DOE/RL-89-03
Revision 3

Hanford Facility Dangerous Waste Permit Application, 616 Nonradioactive Dangerous Waste Storage Facility

Date Published
March 1997

EO 41129
SHEET 2
OF 2

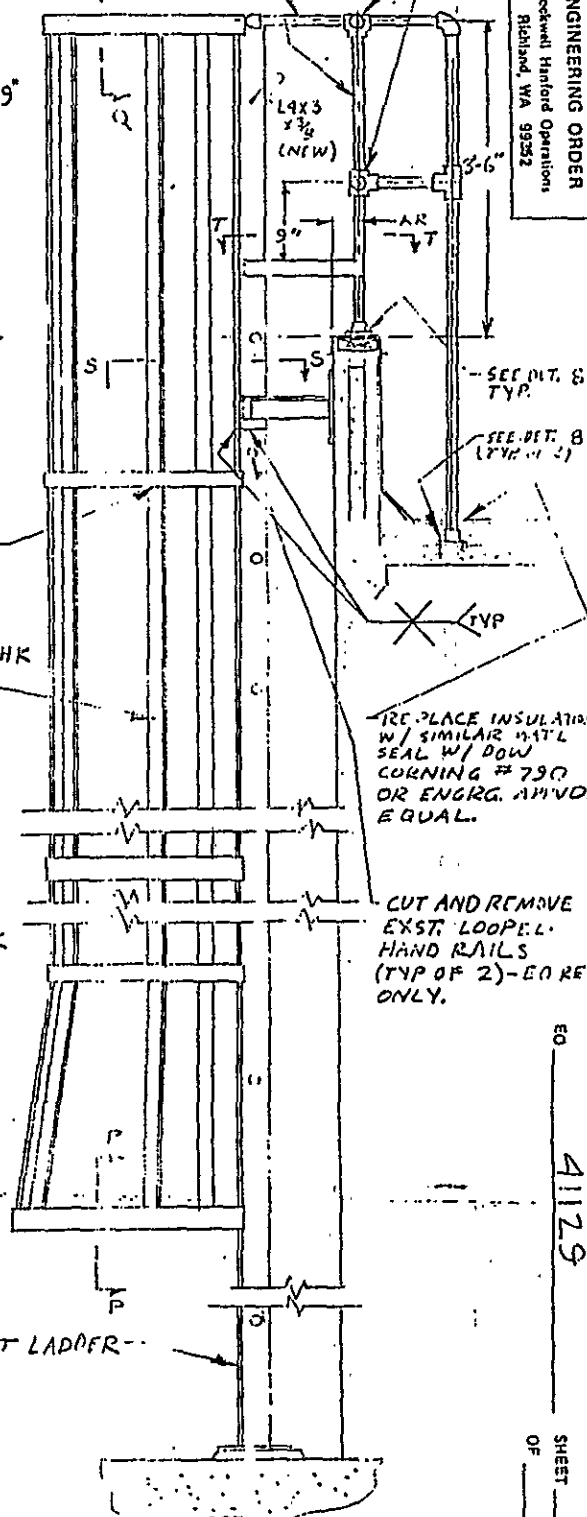
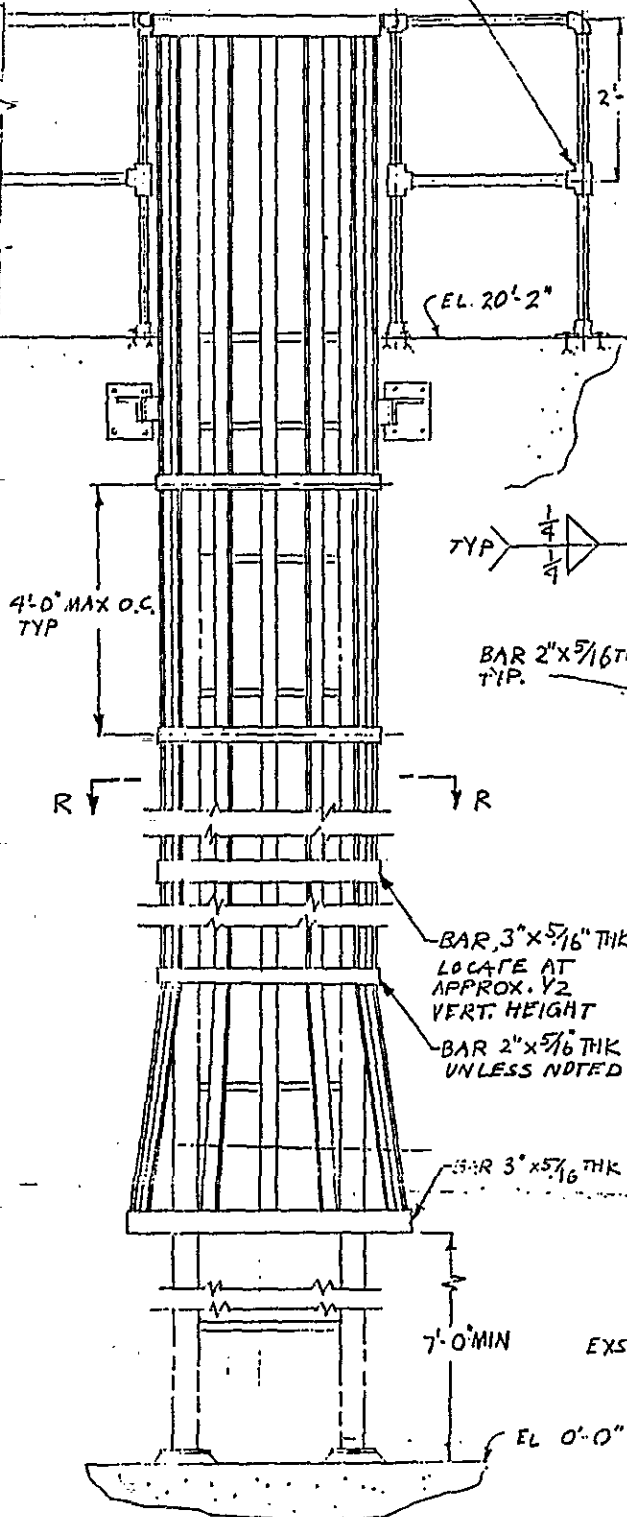
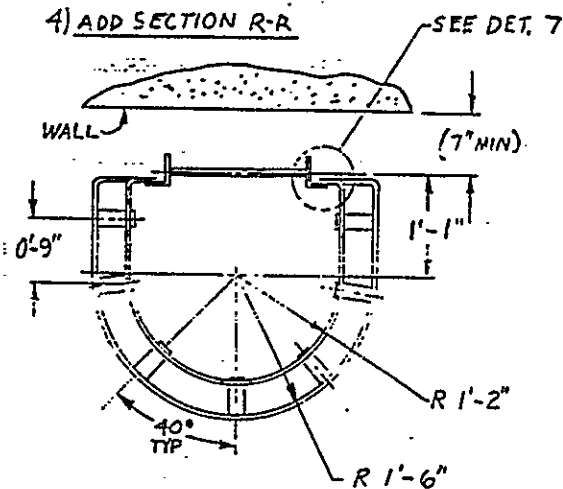
3) REVISE DETAIL G:

SIDE OUTLET TEE, SLIP-ON, HOLLANDER
"SPEED-RAIL" #11 - OR EQUAL (TYP. 4 PL.)

SECTION R-R
SCALE: NONE

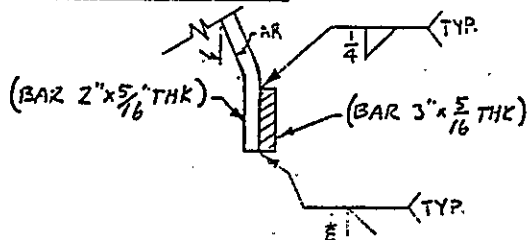
4) ADD SECTION R-R

SECTION P-P
SCALE: NONE

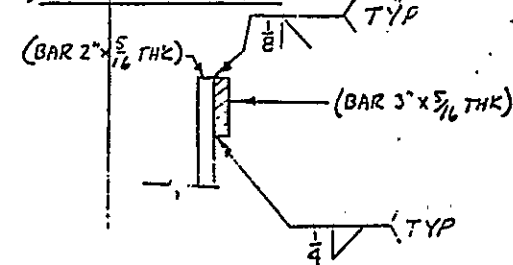
6) ADD SECTION P-P:

SECTION Q-Q
SCALE: NONE

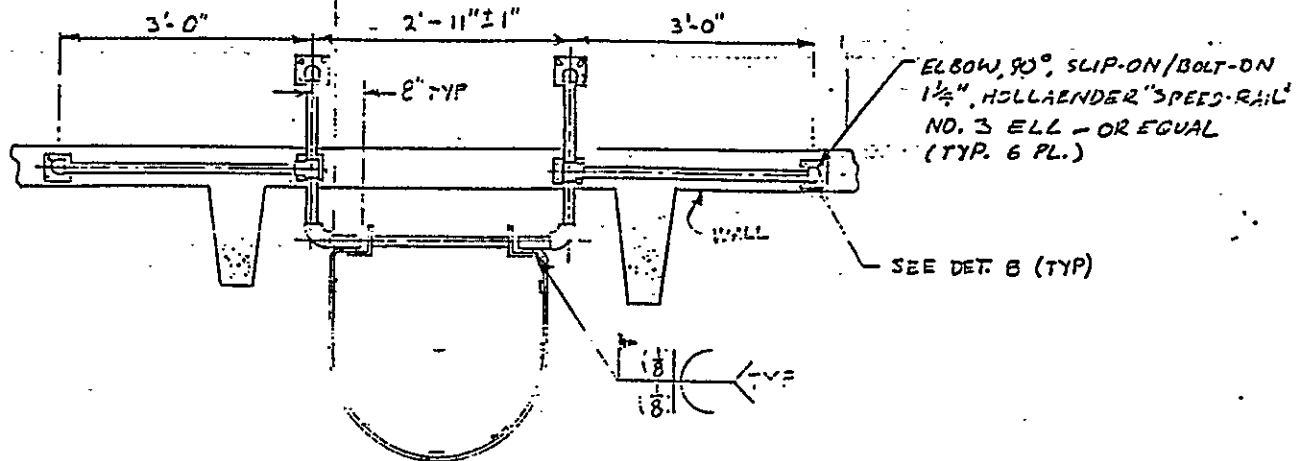
7) ADD SECTION Q-Q:

SECTION U-U
SCALE: NONE

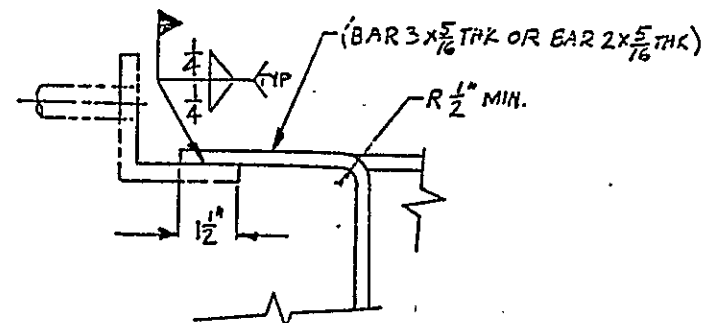
5) ADD SECTION U-U

DETAIL 7 (TYP)
SCALE: NONE

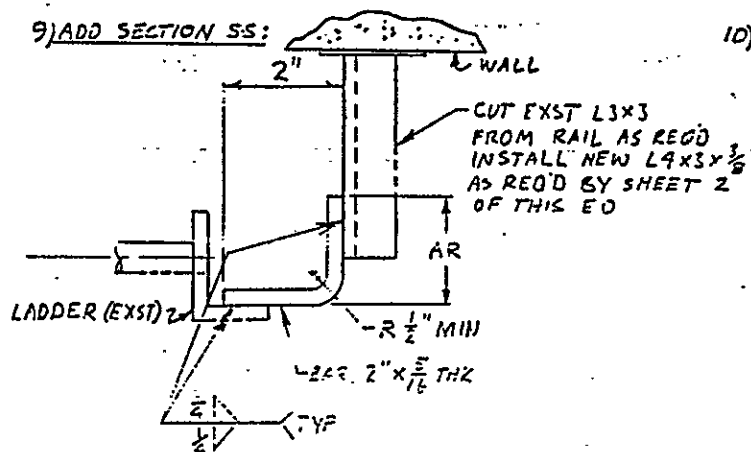
8) ADD DETAIL 7:

SECTION S-S (TYP.)
SCALE: NONE

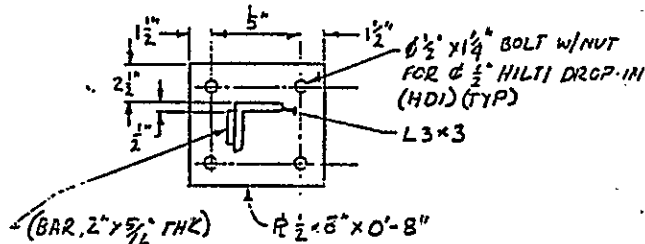
9) ADD SECTION S-S:

SECTION L
SCALE: NONE

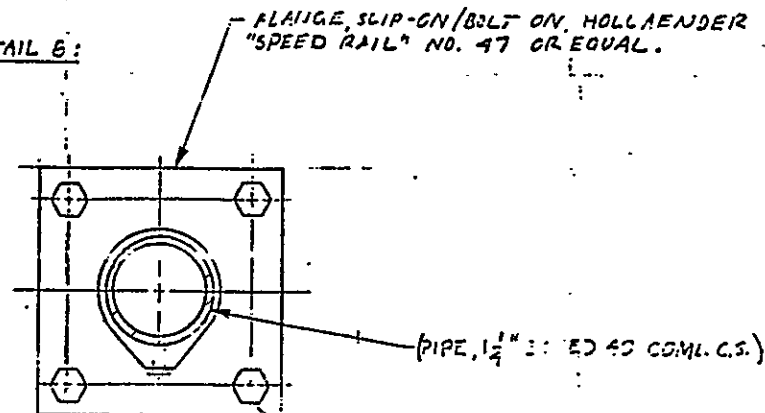
12) REVISE SECTION L:
(TO SHOW POSITION OF BAR, 2" x 5/16 THK)

DETAIL 8 (TYP.)
SCALE: NONE

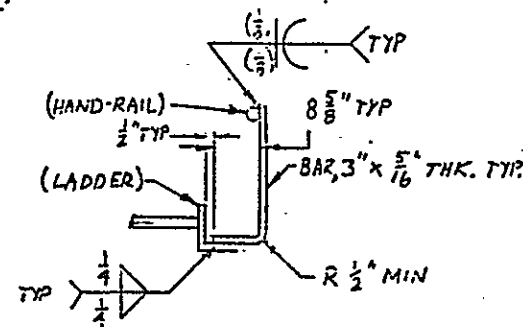
10) ADD DETAIL 8:

FLANGE, SLIP-ON/BOLT ON, HOLLANDER
"SPEED RAIL" NO. 47 OR EQUAL.

DETAIL 12
1

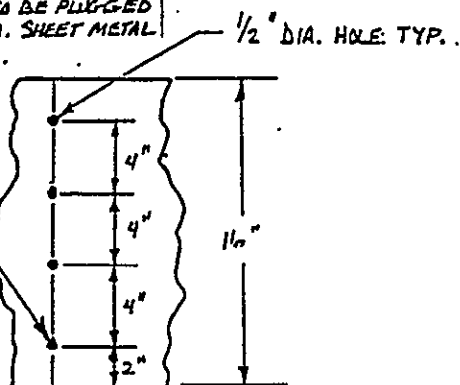
1) ADD DETAILS 12-15 TO DRAWING H-6-1559, SHT. 2, REV. 2 PER
ATTACHED PAGE 3.

HOLES ARE TO BE PLUGGED WITH 1/2" DIA. SHEET METAL HOLE PLUGS.

DETAIL 13
1

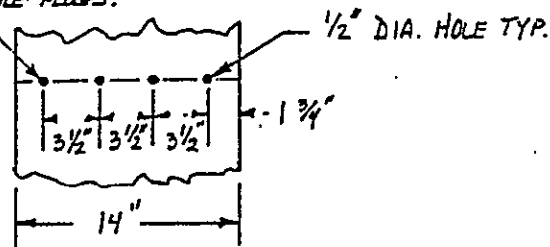
HOLES ARE TO BE PLUGGED WITH 1/2" DIA. SHEET METAL HOLE PLUGS.

DETAIL 14
1

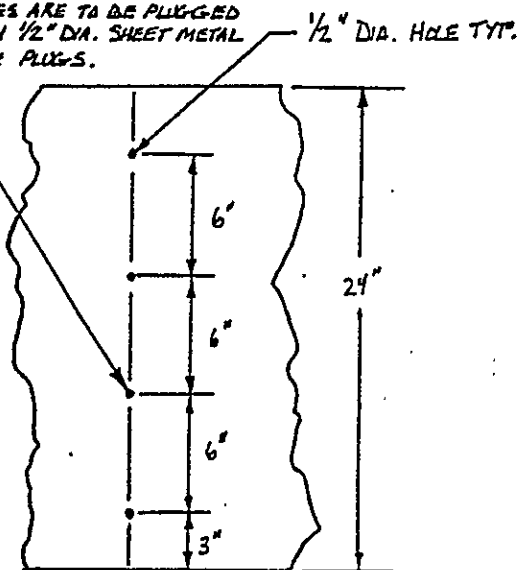
HOLES ARE TO BE PLUGGED WITH 1/2" DIA. SHEET METAL HOLE PLUGS.

DETAIL 15
1

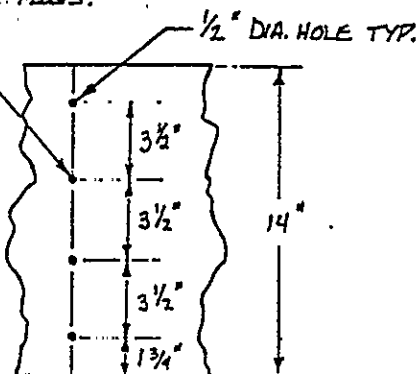
HOLES ARE TO BE PLUGGED WITH 1/2" DIA. SHEET METAL HOLE PLUGS.

FROM DRAWING H-6-1559 SHEET 3

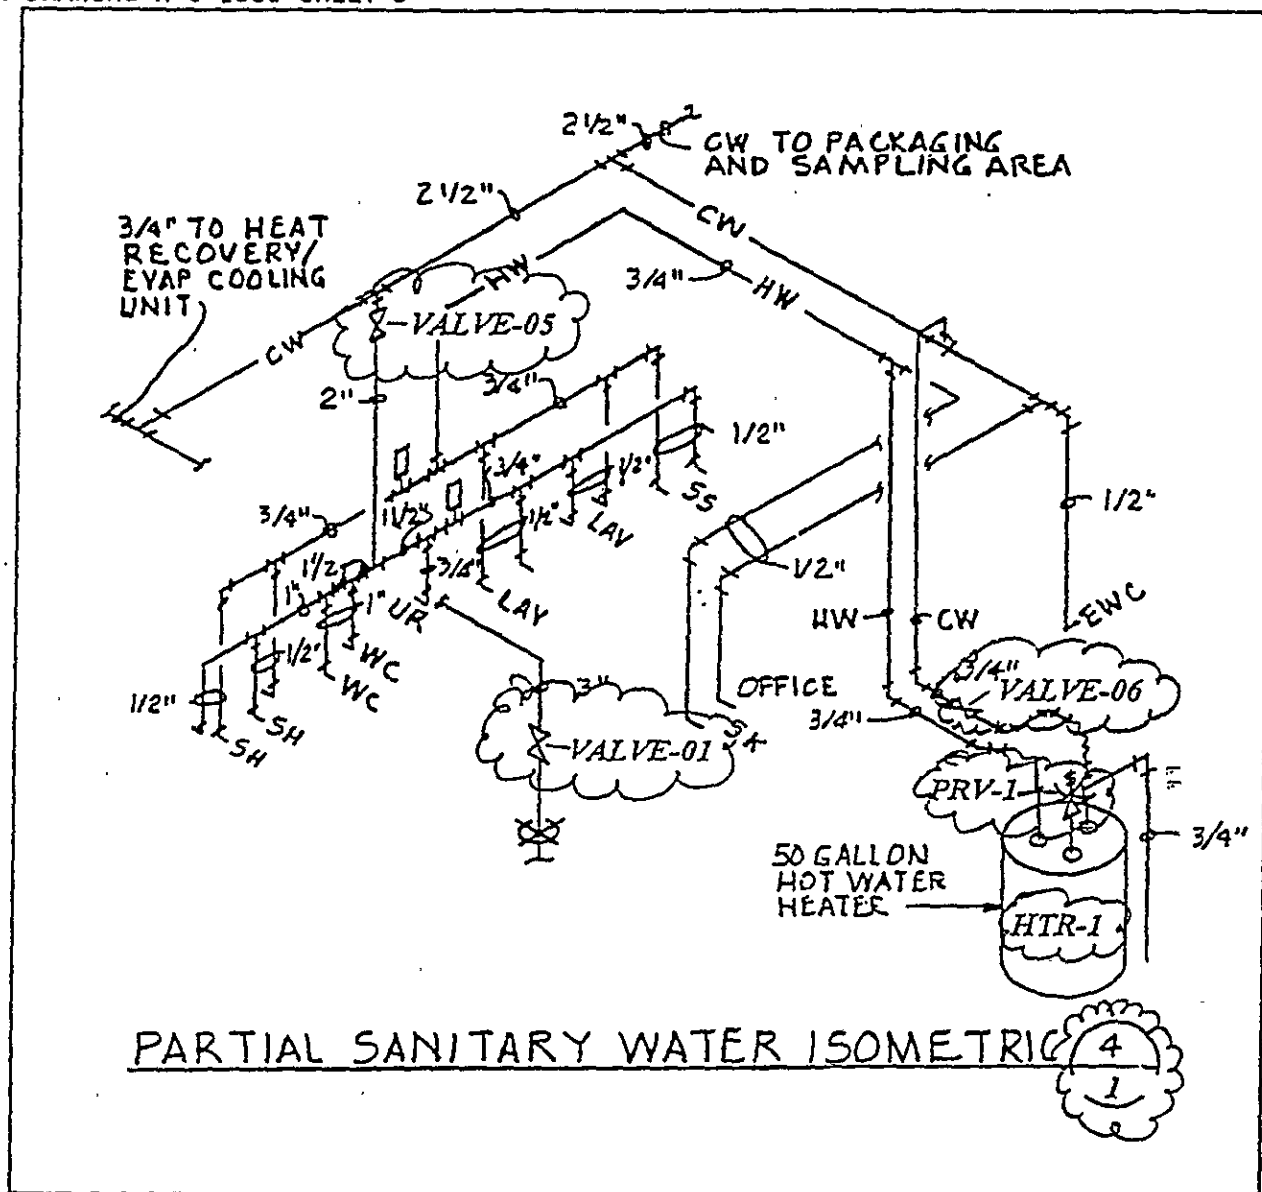
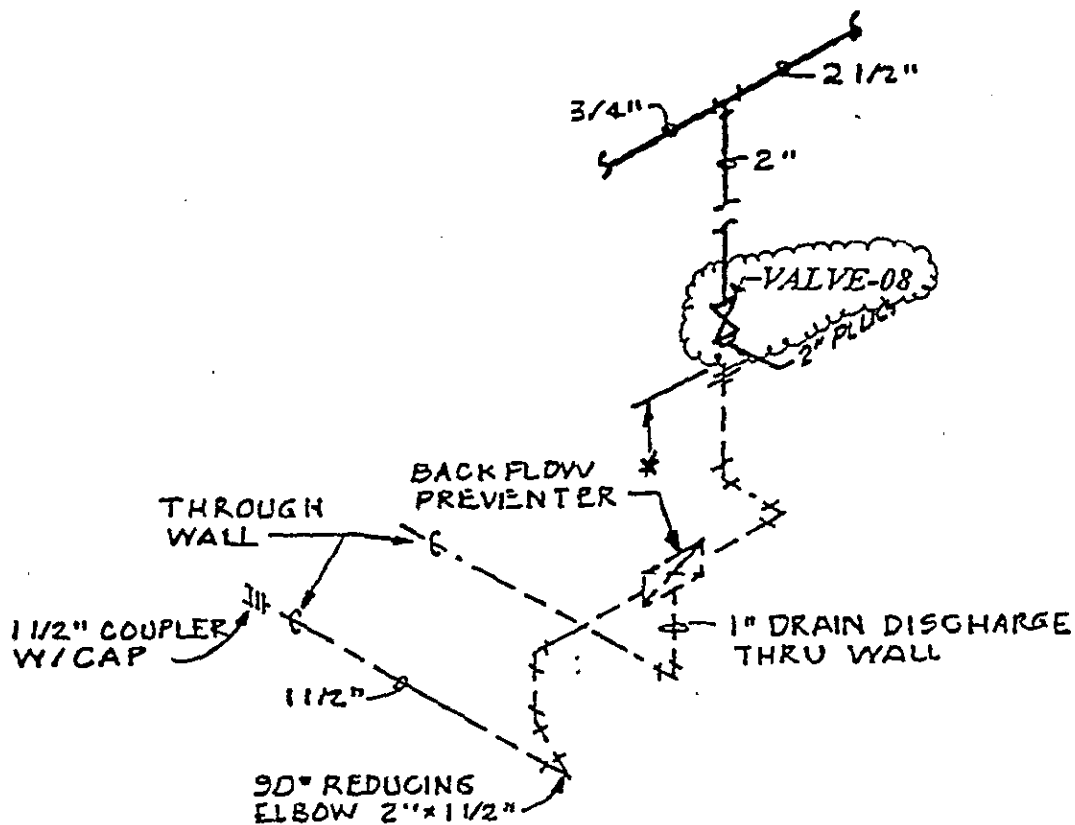
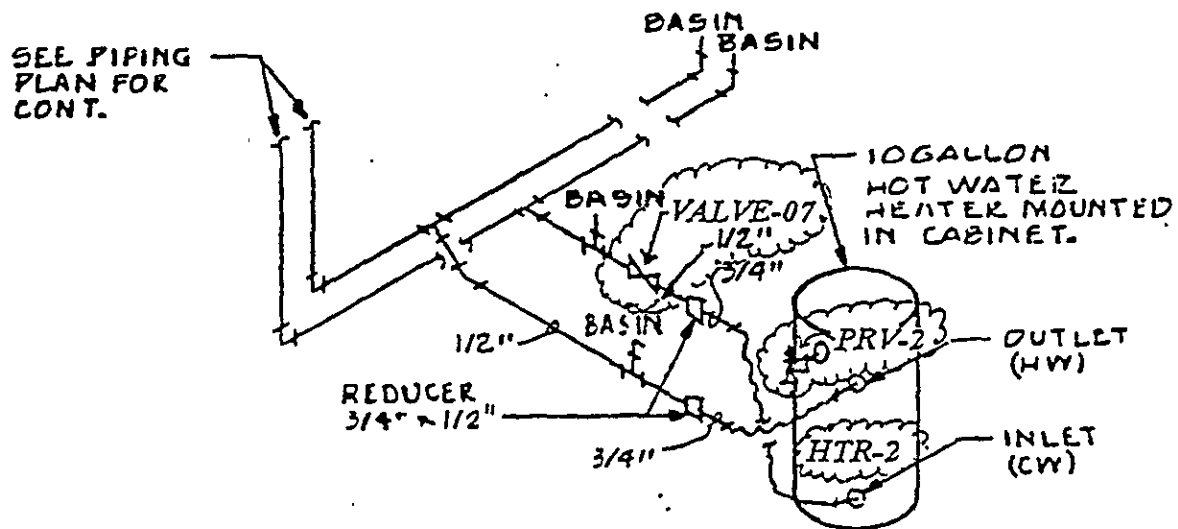
12. Description of Change Block 8 Continued: H-6-1559 Sh. 1 Rev. 4 and Sheet 3 Rev. 1 1: THIS ECN IS TO SUPERSEDE ECN #605641 ENTIRELY. 2: Add valve and hose bib numbers to H-6-1559 SH 1 REV 4 as shown in the clouded areas of sheets 6&7 of this ECN. 3: Add valve numbering to details 4, 6 & 7 on drawing H-6-1559 sh 3 rev 1 per clouded areas on pages 3, 4 & 5 of this ECN 4: Correct Drawing targets on H-6-1559 sheets 1&3 to accurately reflect proper drawing references as indicated in clouded areas on sheets 3, 4, 5 & 7 of this ECN. 5: Add hose bib #5 (HB-05) to H-6-1559 sheet 1 rev 4 as shown on page 7 of this ECN. CONTINUED ON PAGE 3 OF THIS ECN			
13a. Justification (mark one) As-Found <input type="checkbox"/>	Criteria Change <input checked="" type="checkbox"/>	Design Improvement <input type="checkbox"/>	Environmental <input type="checkbox"/>
Facilitate Const. <input type="checkbox"/>	Const. Error/Omission <input type="checkbox"/>	Design Error/Omission <input type="checkbox"/>

5: Add label schedule as shown on page 8 of this ECN to H-6-1559 sh 1 rev 4 and add note to H-6-1559 sh 3 rev 1 to refer to sheet 1 for the label schedule.
